APPLICATION FOR CONDITIONAL USE PERMIT

Case No. 1989-14-CUP

HENRY AFRICA'S
DECK & BEACH ADDITION

SITE PLAN REVIEW

THE DECK WILL BE BUILT USING POST & BEAM HEAVY TIMBER CONSTRUCTION. USE WILL BE SEASONAL ON FAIR WEATHER DAYS. VOLLEY BALL TOURNAMENTS WILL BE HELD ON OCCASION W/ SPECTATOR SEATING AT TABLES AROUND THE COURT. USE OF THE DECK WILL BE STRICTLY TIED TO OPERATION OF THE EXISTING RESTAURANT.

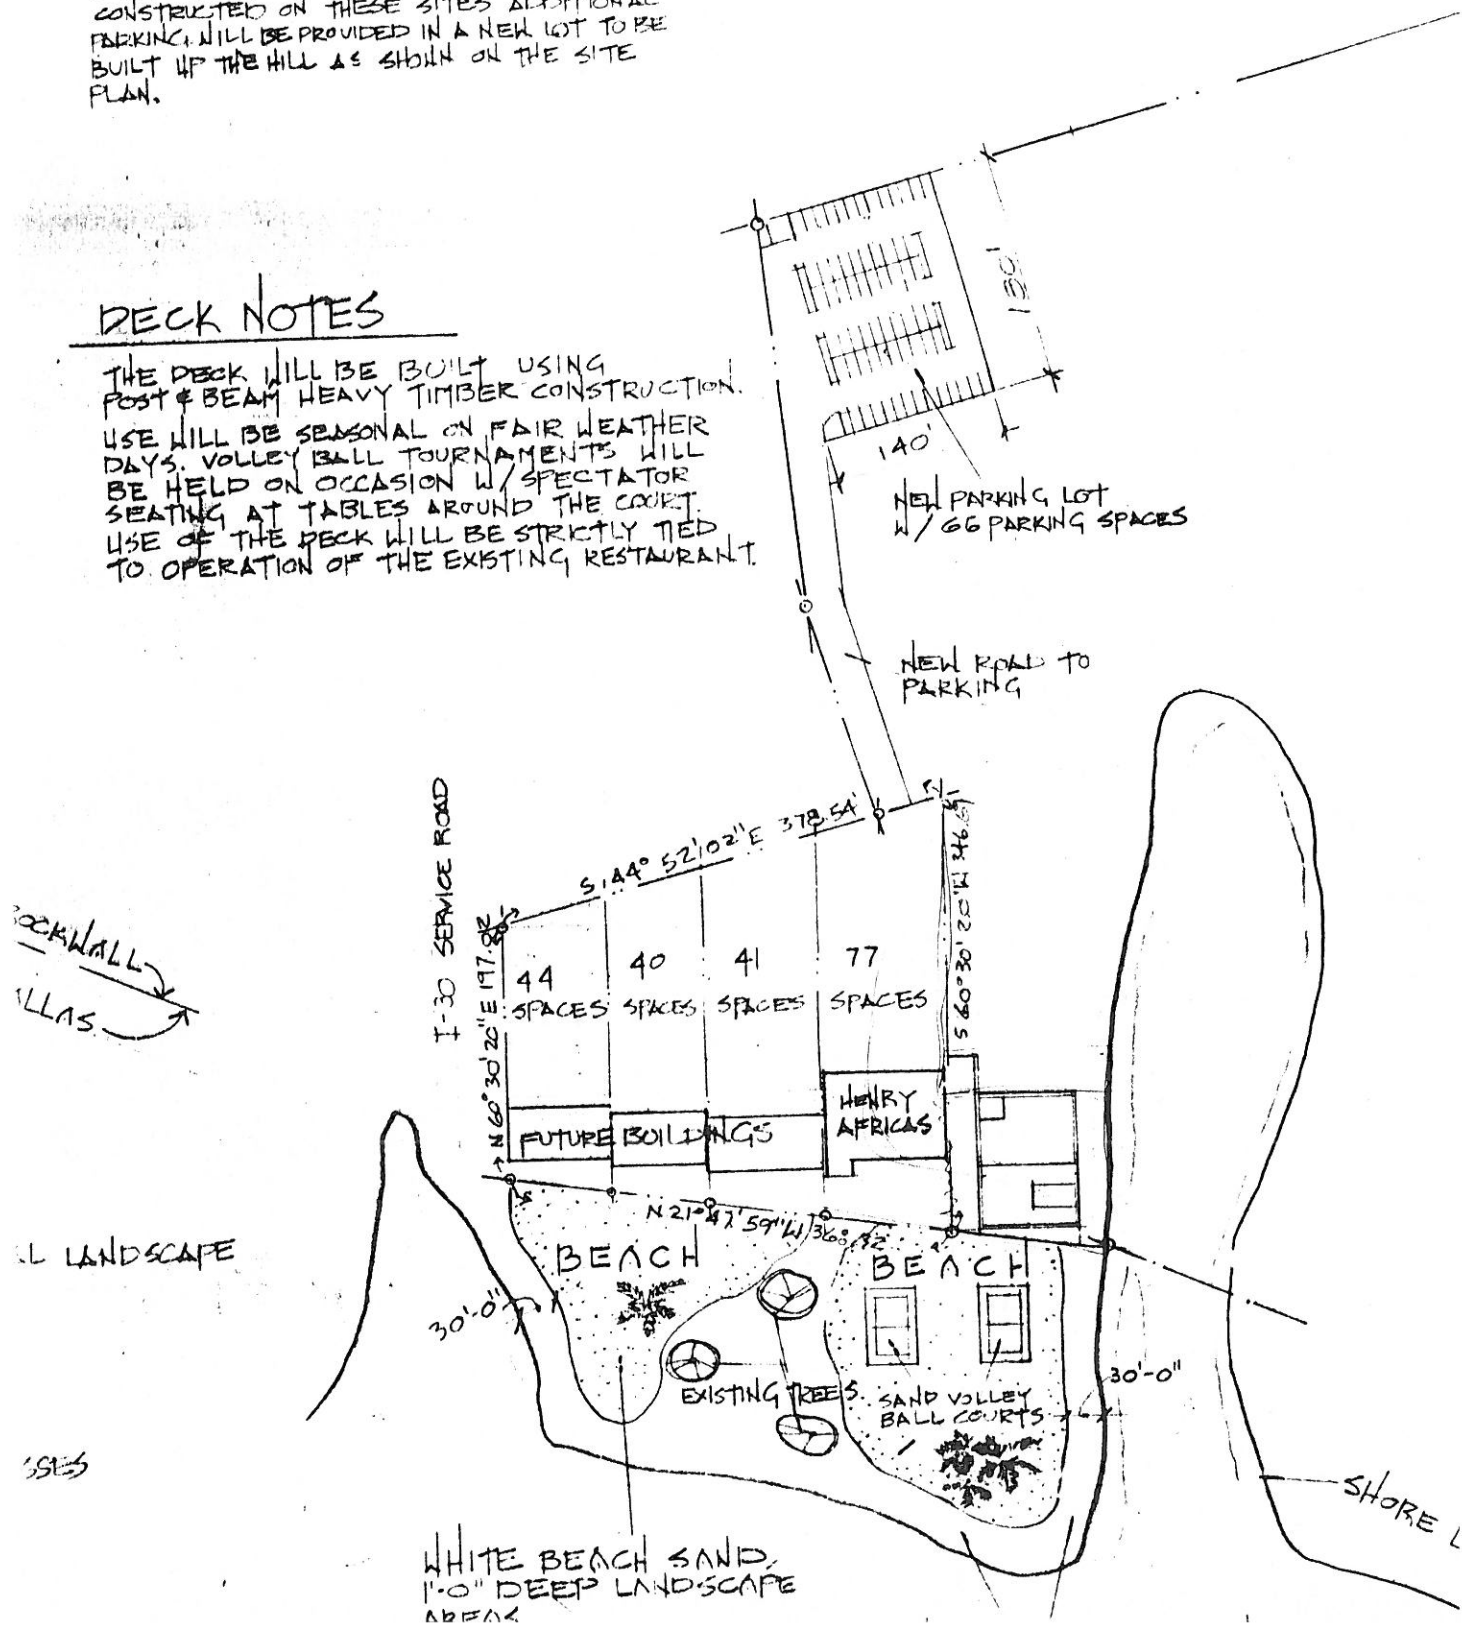
1. With the addition of the deck area the required landscaping would increase by 11,088 sq. ft. The minimum landscaping for that area would be 15% or 1,664 sq. ft. The only area that would be available for landscaping would be along the inlet. This is planned at some future time to be used as a docking area to provide boat access to the development. It is also going to be approximately 4-5 feet below the deck when it is constructed. The applicant has been asked to address the issue of landscaping this area. They may request a waiver to those requirements. In light of the location of this deck with the proximity of the take line and the improvements that will be placed there, and due to the height of the deck additional landscaping would probably not enhance this area significantly. We will hear from the applicant Thursday night regarding this matter.

2. The parking will have to be increased to 75 spaces in order to meet the standard parking requirements. The parking will be installed at the time of construction of the deck.

3. They are proposing to place the required parking for the deck in the eastern part of PD-7 as shown on the site plan. The drive for this new parking needs to be realigned to tie into the site plan for Henry Africa. The landscaping ordinance requires that a parking lot with more than two rows of parking to have internal landscaping. We have asked them to provide the area within the parking lot. Again, they may request a delay from the landscaping requirements for the parking lot until their development reaches this area. They will address this Thursday night.

4. The applicant plans to utilize wood that has been salvaged from another building for the deck. If the wood meets the building code structural requirements it could be used, however if it cannot be rated it cannot be used.

5. There has been no indication by the applicant that they would want to be able to have entertainment on the deck such as bands or dancing, etc. We have requested them to indicate what, if any, entertainment they might want to utilize on the deck. The Commission may want to consider a condition in the permit regarding the provision of entertainment. We have in the past had some noise complaints from Lakeside Village regarding the bands at Culpepper's.

1. That the additional landscaping on Lot 4 be approved as submitted with the stipulation that a minimum of 2 trees be planted in the ground within the deck area. The location of the trees would be decided by the applicant.

2. That the landscaping and parking materials requirements for the additional parking and drive be temporarily waived for a period of two years or the construction of Phase 2 of the Harbor development, whichever comes first. The temporary parking lot and drive will be constructed of a compacted rock base with a seal coat surface.

3. That adequate lighting will be provided for the additional parking area.
4. That adequate fixtures for both the deck and for the beach use will be provided in the restrooms.

5. The entertainment on the deck is approved with the condition that the use of entertainment would be reviewed at the end of one year.
6. The plat is approved with the condition that an access easement is provided on the additional parking area.
